October 21st, 2020

RE: NWB Technical Review of the 2019 Annual Report for the Meliadine Project; Water Licences Nos: 2AM-MEL1631 and 2BB-MEL1424

NWB-4 Saline Water Management

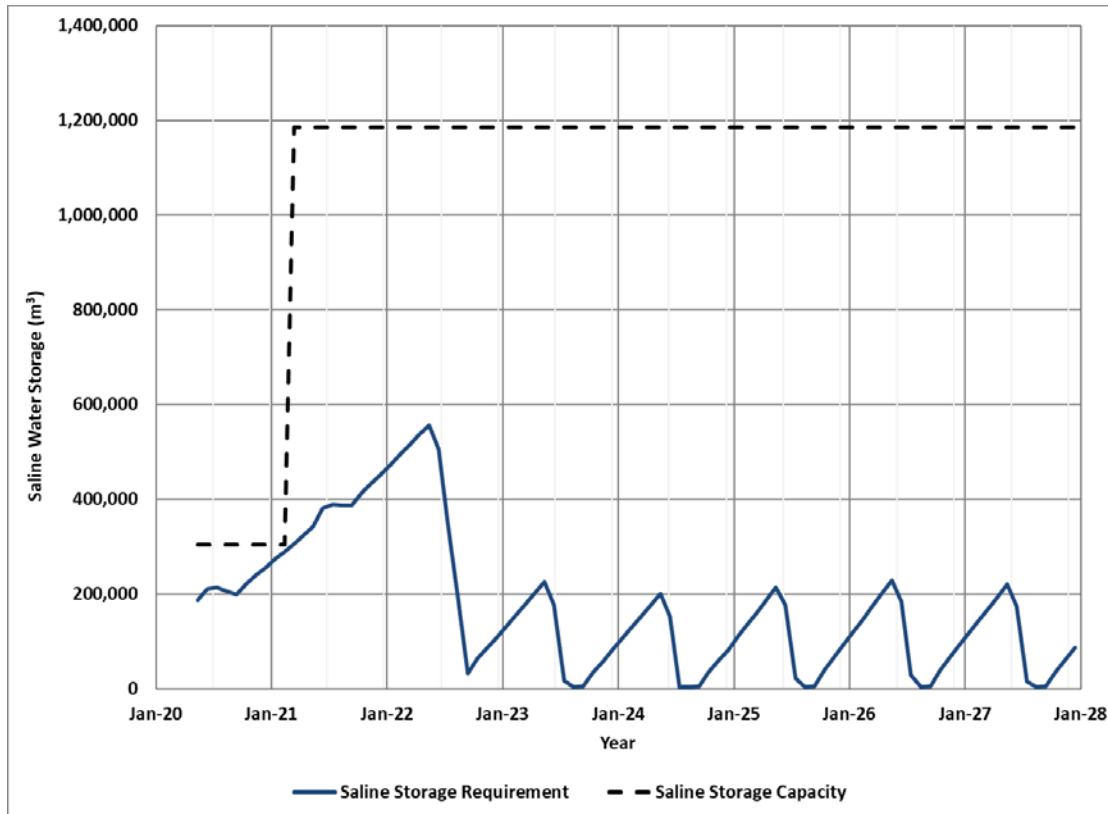
List all long-term strategies that were considered in response to the increased groundwater inflow rates;

Provide more information regarding the possibility to stop mining at the Tiriganiaq Pit 2 in order to accommodate the excess saline water.

As described in the Groundwater Management Plan, Version 5, the proposed long-term strategy of discharging to Melvin Bay via a waterline will be required to ensure sustainability of saline water storage.

In the medium-term, Tiriganiaq Pit 2 will be applied as temporary storage for saline water. Storage within Tiriganiaq Pit 2 is expected for to be available in Q2 2020. The combined saline water storage capacity available in SP1, SP4, and Tiriganiaq 2 Pit from 2021 to 2027 is 1,184,852 m³.

The figure and the table below shows the available saline storage capacity over the mine life. This is assuming the operation of the Waterline during the summer 2022.
